DOCUMENTS ON DISC

EXHIBIT INDEX

**Port of Anchorage Expansion Project
35 % Design Review
Prepared for the U.S. Army Engineer District, Alaska
By the
U.S. Army Engineer Research and Development Center
Geotechnical and Structures Laboratory
Vicksburg, Mississippi
December, 2006 (Revised 22 December 2006)**

Figure 1 - Port of Anchorage - Proposed Expansion - Parametric Slope Stability Analysis

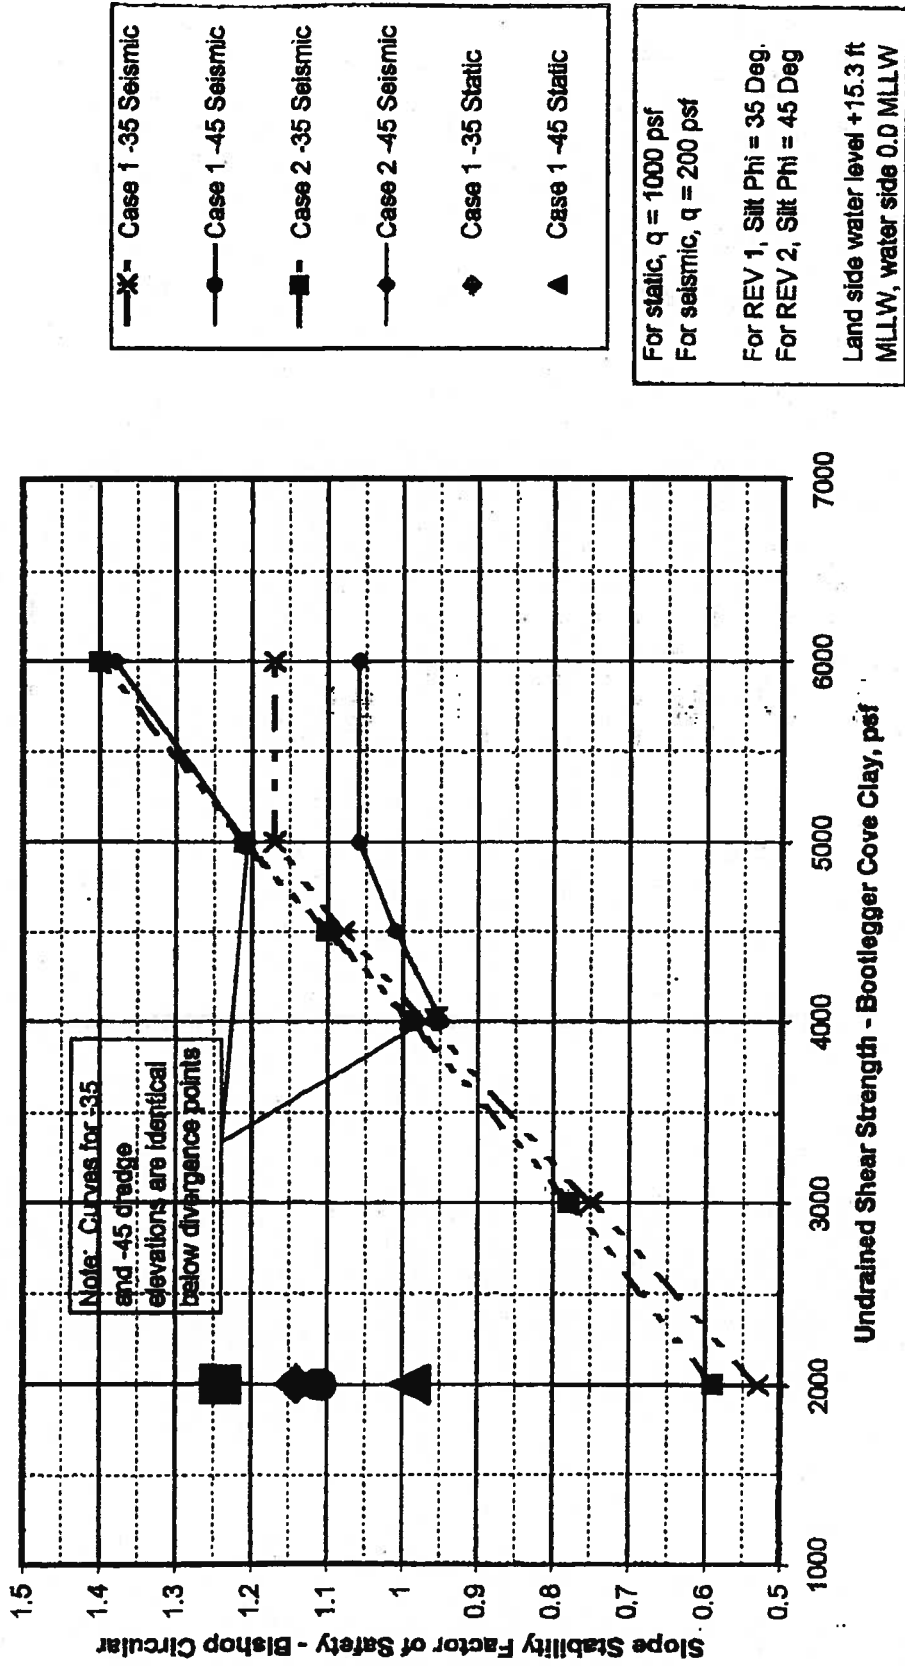
The analysis was conducted using PCSTABL6 for the conditions described above for the requested cases. Circular slip surfaces were analyzed using the modified Bishop method. Results from Case 1 and Case 2 were plotted in terms of factor of safety versus undrained shear strength for overall comparison on Figure 1.

The Case 2 end of construction cases indicated factors of safety of 1.24 and 1.11 for the -35 and -45 ft dredge elevations respectively. These are also plotted on Figure 1 as individual points corresponding to an undrained shear strength of 2,000 psf.

appear, but the most critical circle is very shallow, immediately below the bottom of the sheet piling. For the 6,000 psf case, all the critical circles depicted are shallow circles. This pattern agrees with expected results in that as the deeper soils become firmer, the resulting critical circles are shallower. With a firm base, the frictional properties of the shallower materials govern global stability, hence the asymptotic behavior observed in Figure 1 for the Case 1 conditions where the surface materials have $\phi = 35^\circ$.

**Figure 2 - Port of Anchorage - Borehole TH-1 - Shear Strength Testing Results
Undrained Shear Strength vs Effective Confining Pressure**

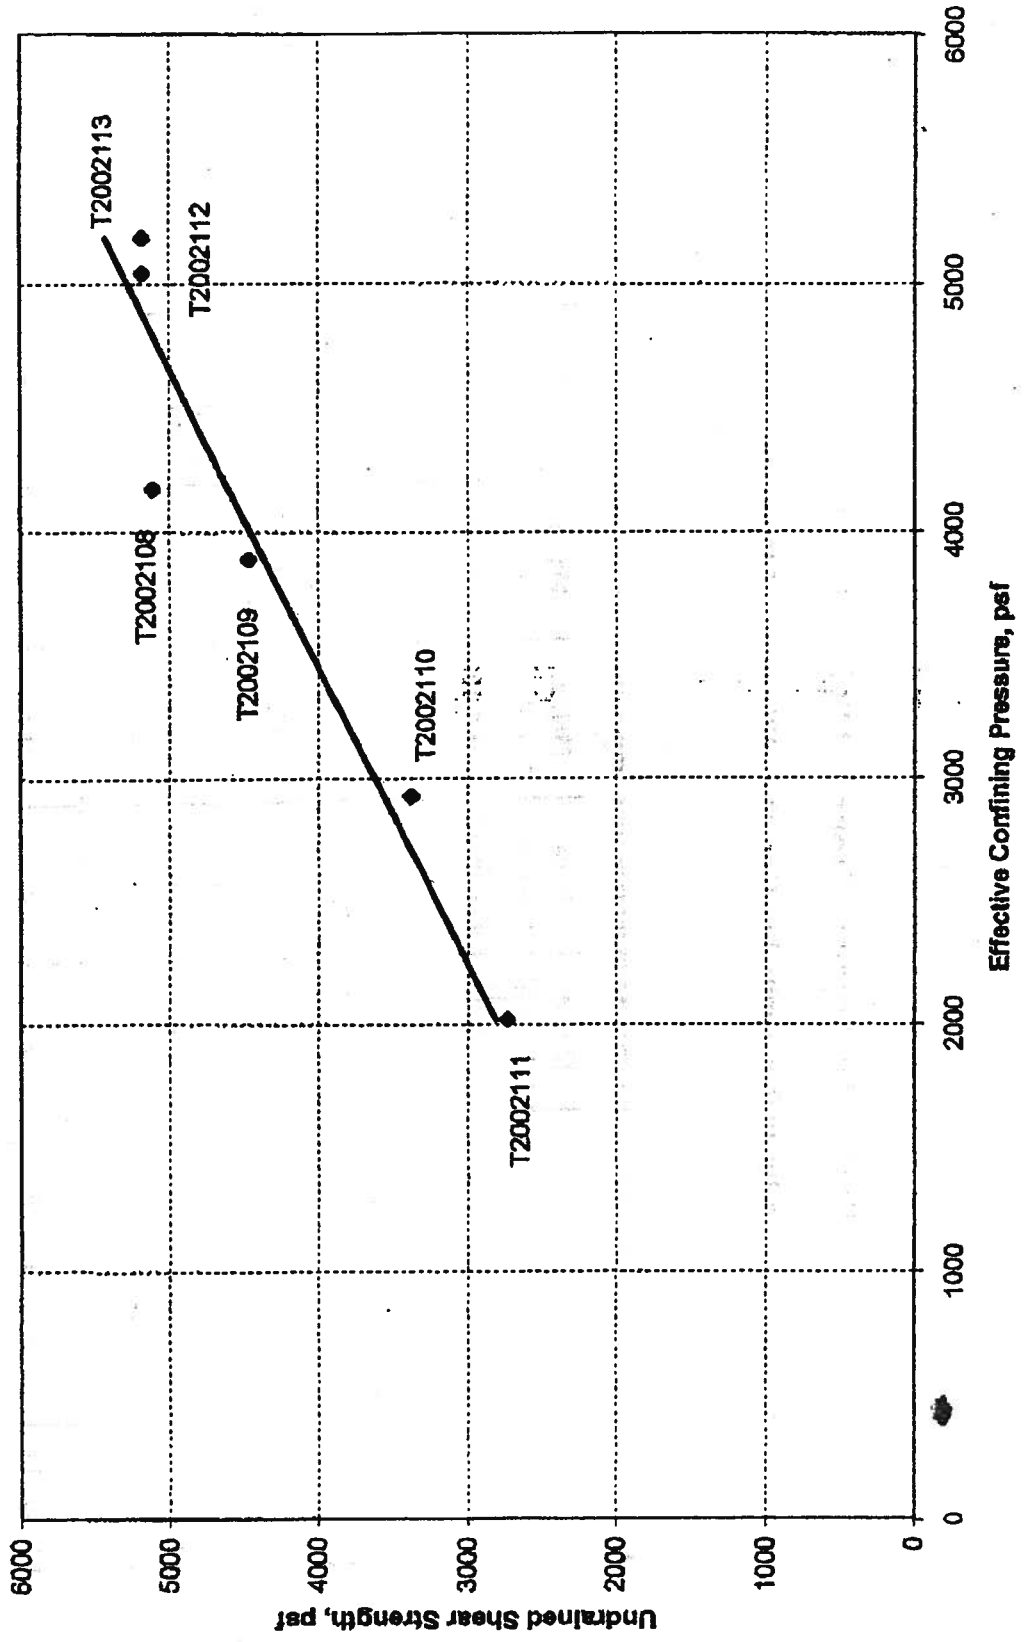
3. The triaxial tests results given in Table 1 also indicate that the undrained shear strength, S_u , of the clay materials increases as the initial effective confinement pressure increases. A graphical representation of the relationship between the undrained shear strength of the clay and the initial effective confinement, obtained from the triaxial tests results is shown in Figure 2. (The effective confinement for the unconfined compression test was taken as the effective overburden pressure at the sample depth).

2. Figure 2 of the PN&D report includes a total stress envelope, developed based on the results from unconfined compressive strength tests, as well as CU triaxial tests. A reading of the text in the report appears to indicate that such an envelope might have been used to assess the overall stability of the fill immediately after construction. In our opinion this procedure will lead to misleading results.

It is a basic tenet of soil mechanics that shear strength parameters c_1 and ϕ from a total stress envelope do not have a physical meaning. Global stability analysis for end of construction and seismic loadings can be carried out using the undrained shear strength of the clays measured at various initial effective confinement values representative of the effective in-situ stress within the deposit.
